**NAC INTERNATIONAL**

**REQUEST FOR ADDITIONAL INFORMATION**

**NAC UNIVERSAL TRANSPORT SYSTEM (NAC-UMS)**

**(TAC. No. L22452, DOCKET No. 71-9270)**

Figure 2.31-1 Accelerometer Time History at the Bottom of the NAC-STC 1/4-Scale Model Cask (75° Oblique Drop)

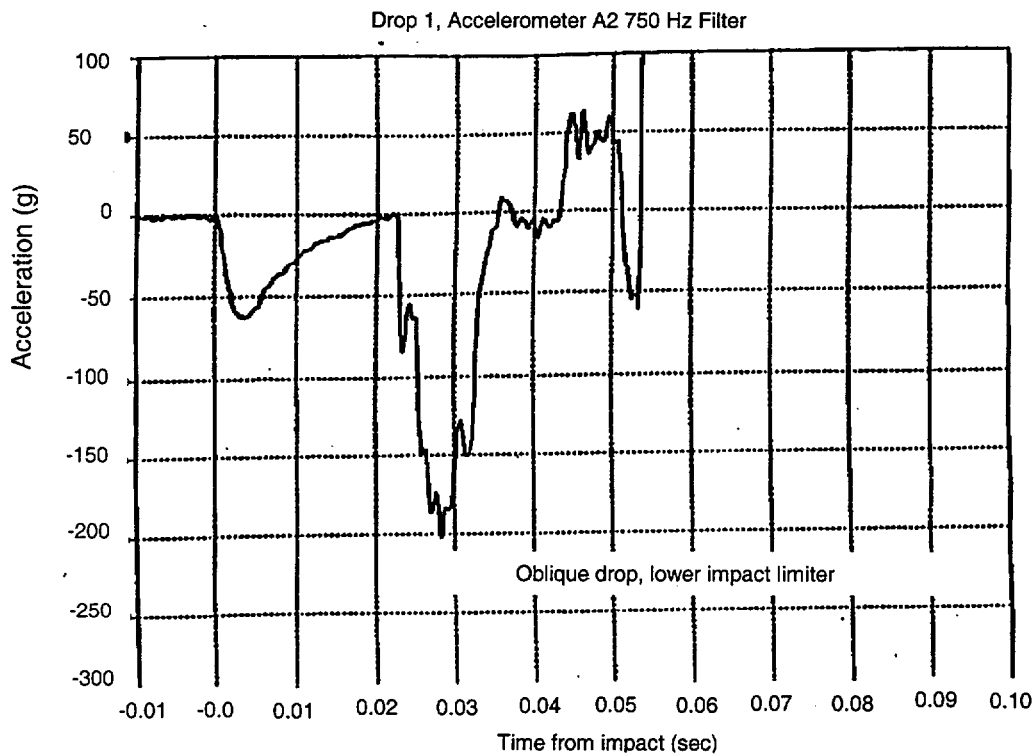
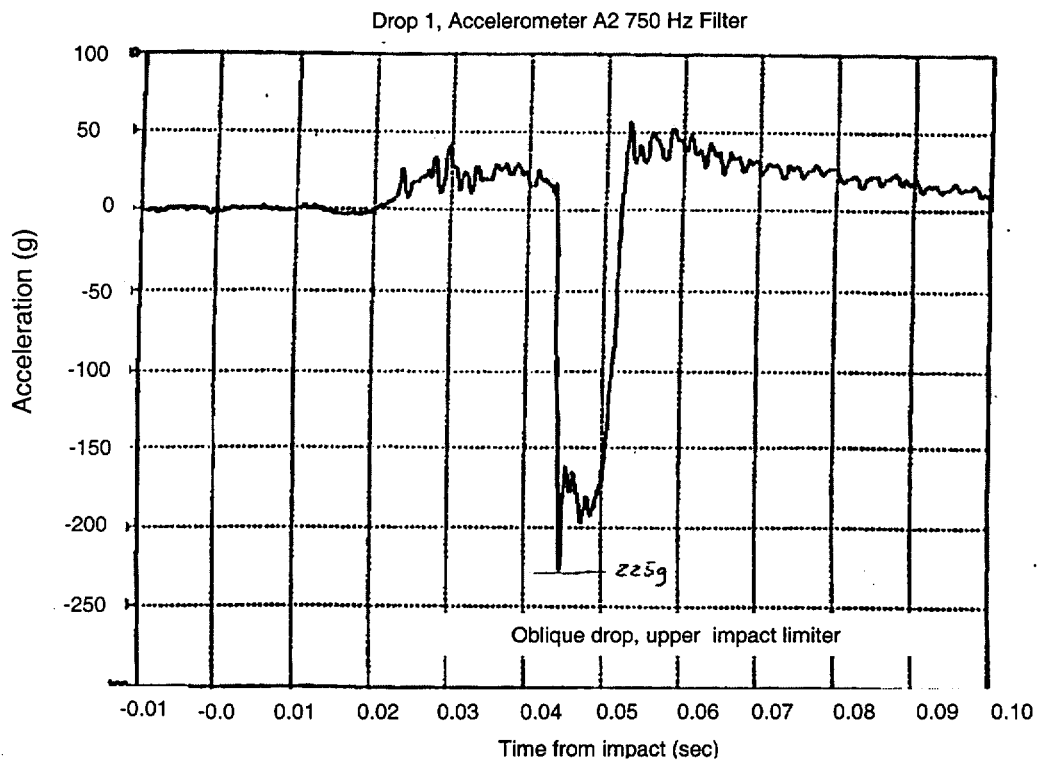
NAC Response to RAI 2-31 (Continued)

Accelerometer data from the NAC-STC oblique drop test are shown in this response as Figures 2.31-1 and 2.31-2 for the accelerometers at the bottom (leading end) and top (trailing end), respectively. Figure 2.31-1 (leading end accelerometer) indicates that from initial impact,  $t = 0$  until  $t = 0.02$  sec, the leading impact limiter experiences an initial negative acceleration peaking at approximately  $-60$  g and returning to zero near  $t = 0.02$  sec. At this time, the trailing end impact limiter (still not in contact with the impact surface) experiences (see Figure 2.31-2) a positive rotational acceleration peaking at less than  $50$ g between  $t = 0.02$  and  $t = 0.045$ . The trailing end then impacts and undergoes a sharp negative acceleration peaking at near  $-225$ g and returning to  $0$ g at  $t = 0.052$  sec. During this same time period (between  $t = 0.045$  sec and  $t = 0.05$  sec) the leading end acceleration peaks at approximately  $65$ g and returns to  $0$ g at  $t = 0.052$ . All significant acceleration excursions of both the leading and trailing impact limiters have ended by  $t = 0.06$  sec and the package reaches equilibrium (at rest) in the horizontal position by  $t = 0.10$  sec.

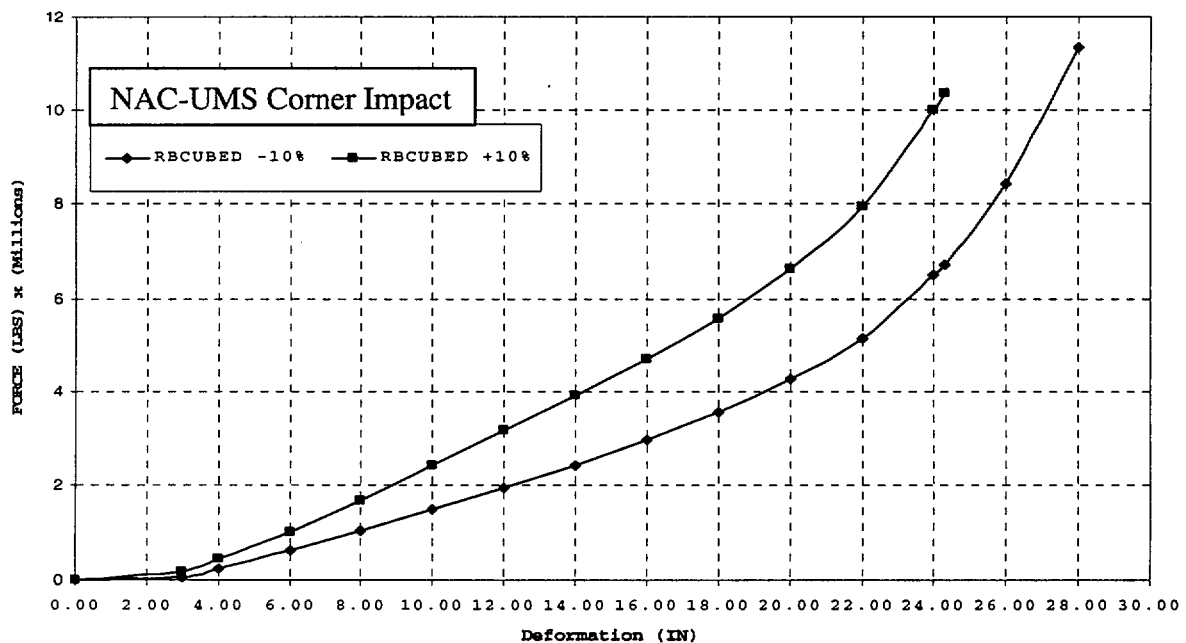
For the identical redwood and balsa wood material properties, the RBCUBED calculated force-deformation curves are expected to have a similar shape for the essentially identical design for the upper and lower impact limiters. Complete and accurate information should be provided, per Section 71.7(a), for evaluating the package free-drop performance under Sections 71.71(c)(7) and 71.73(c)(1).

The curve in Figure 2.6.7.5-12 is incorrectly plotted for the -10% data at a deformation of 3 inches. The figure is revised with the correct data as shown below, but is now renumbered to Figure 2.6.7.5-13 due to other revisions of text. (Note the correction in figure numbers.)

Figure 2.51-1 Upper Impact Limiter Acceleration - 30-ft End Drop

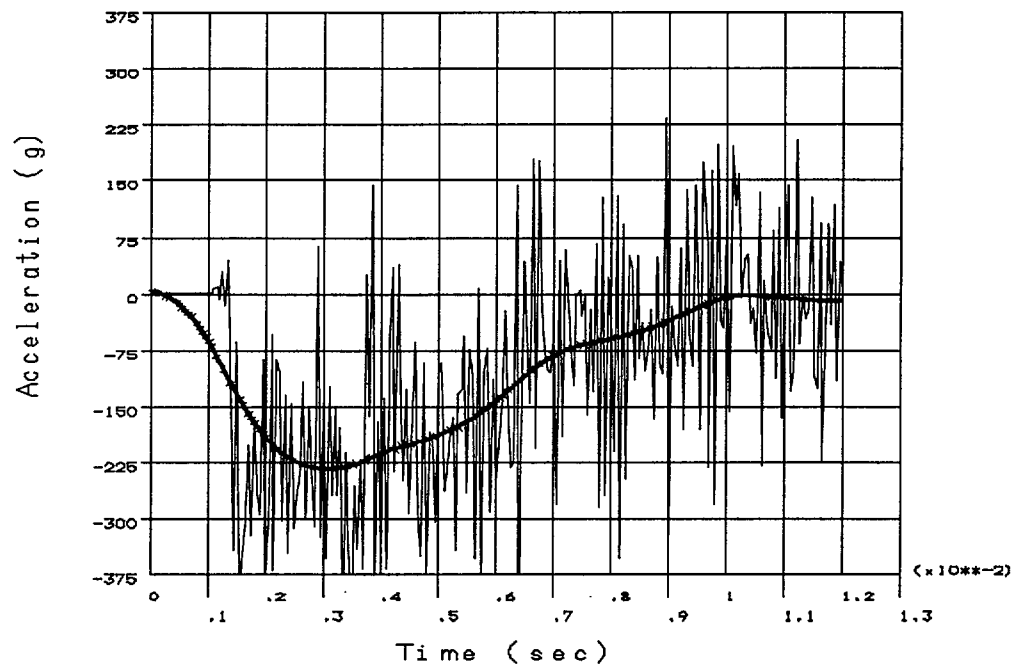
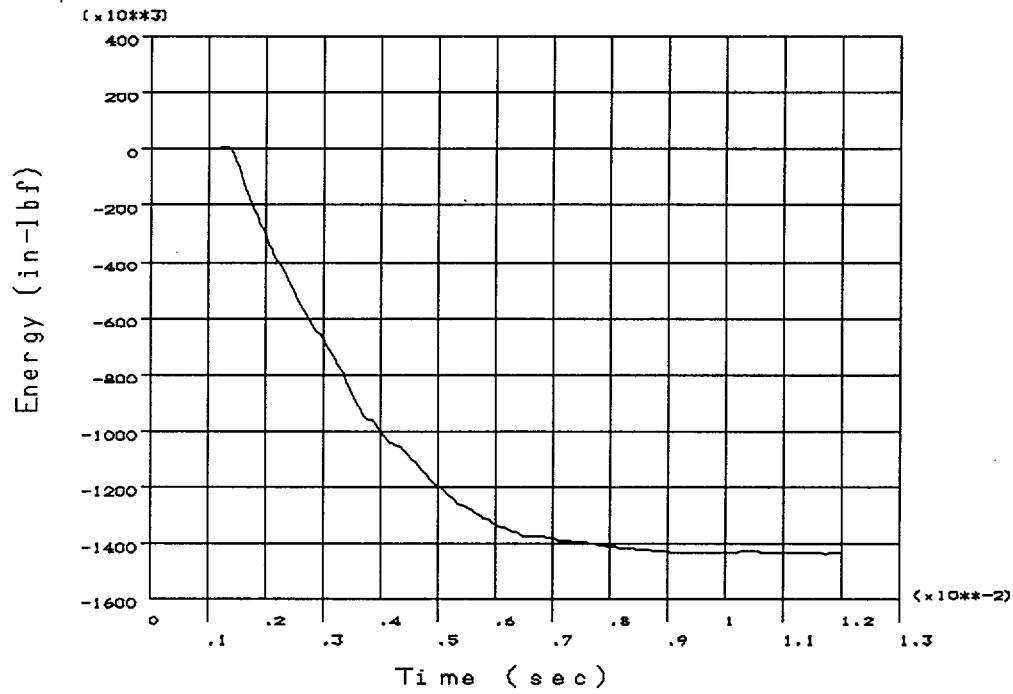
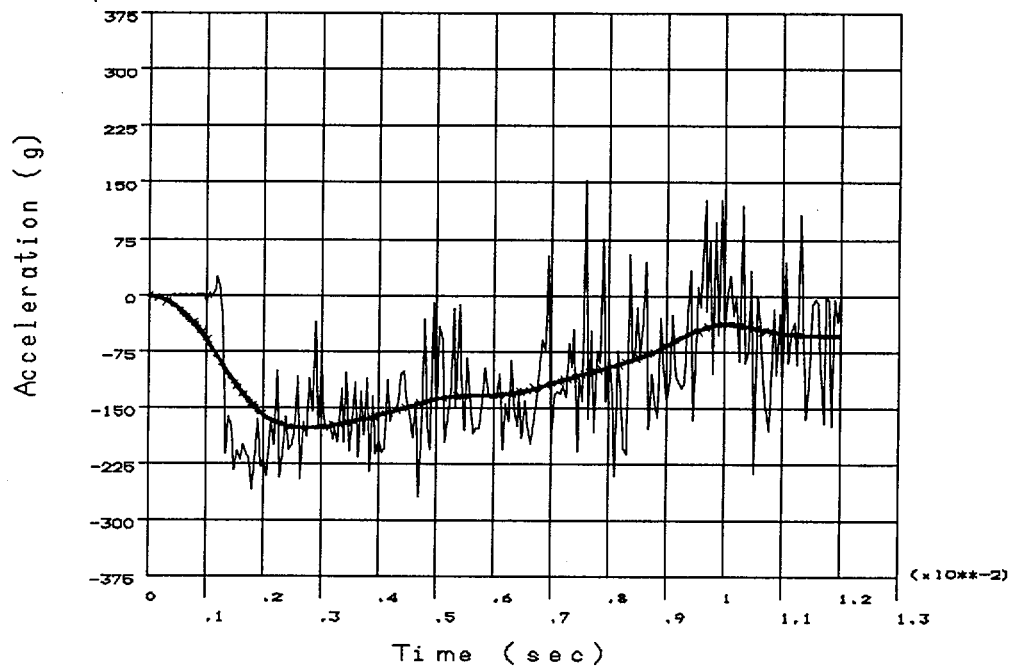
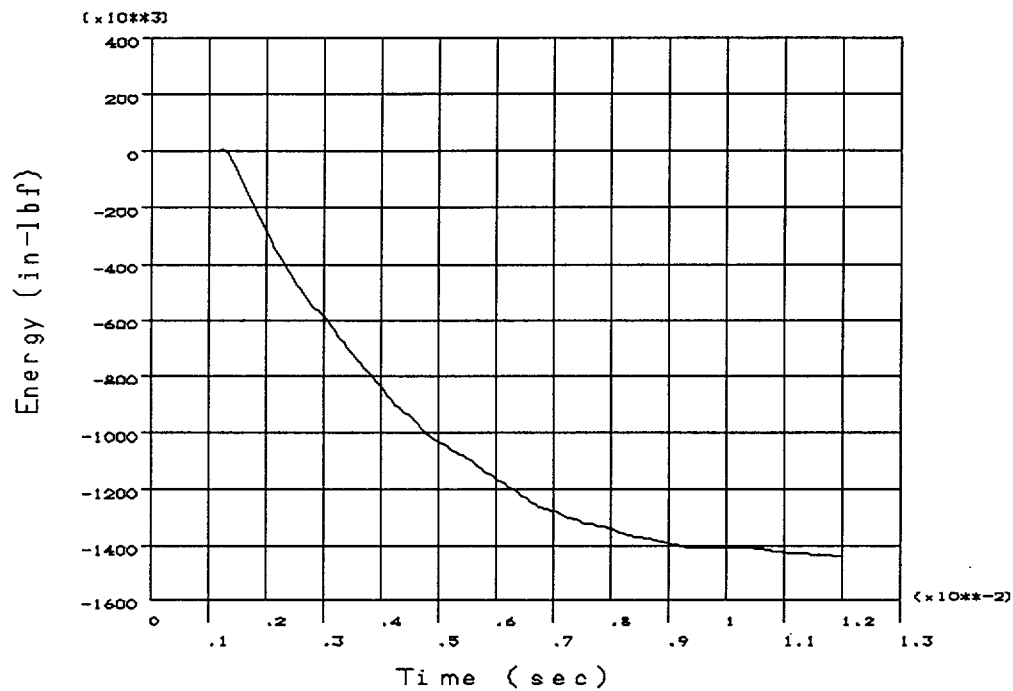
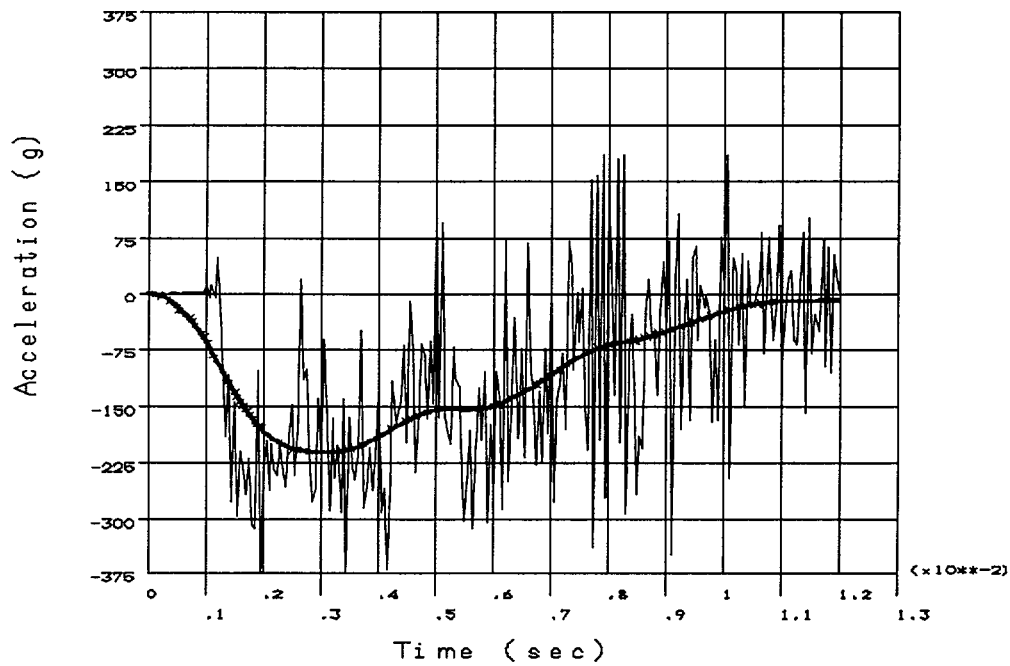
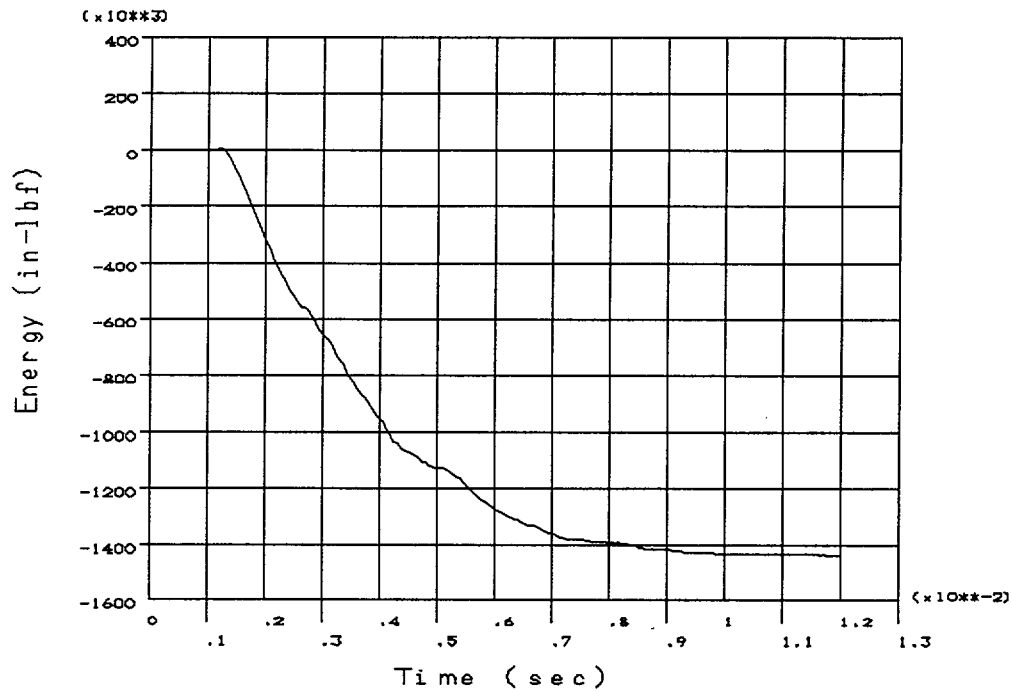
1.        The 1/4-scale cask model should also provide proper simulation of the cask mass moment inertia, in addition to the mass and its center of gravity. The use of weight disks at only the cask top end may not be representative.
2.        The measured acceleration time history in Figure 2.10.3-6 suggests significant cask rocking, which is uncharacteristic of a Universal Transport Cask undergoing side-drop response.
3.        The end-drop acceleration time history in Figure 2.10.3-1 appears to contain much more spurious components than the similar time history for the 1/4-scale drop test conducted for the NAC-STC.

The filtered and unfiltered acceleration time history traces for the 30-foot end and side drop events are provided in Figures 2.51-1 through 2.51-19 of this response. Acceleration data from the three accelerometers used in the 30-foot end drop test and the four accelerometers used in the 30-foot side drop test are presented in the following figures. The filtered data is superimposed on the unfiltered data. The corresponding energy data curves are also provided. The 30-foot corner drop unfiltered and filtered acceleration data are provided in Figures 2.51-15 through 2.51-20.
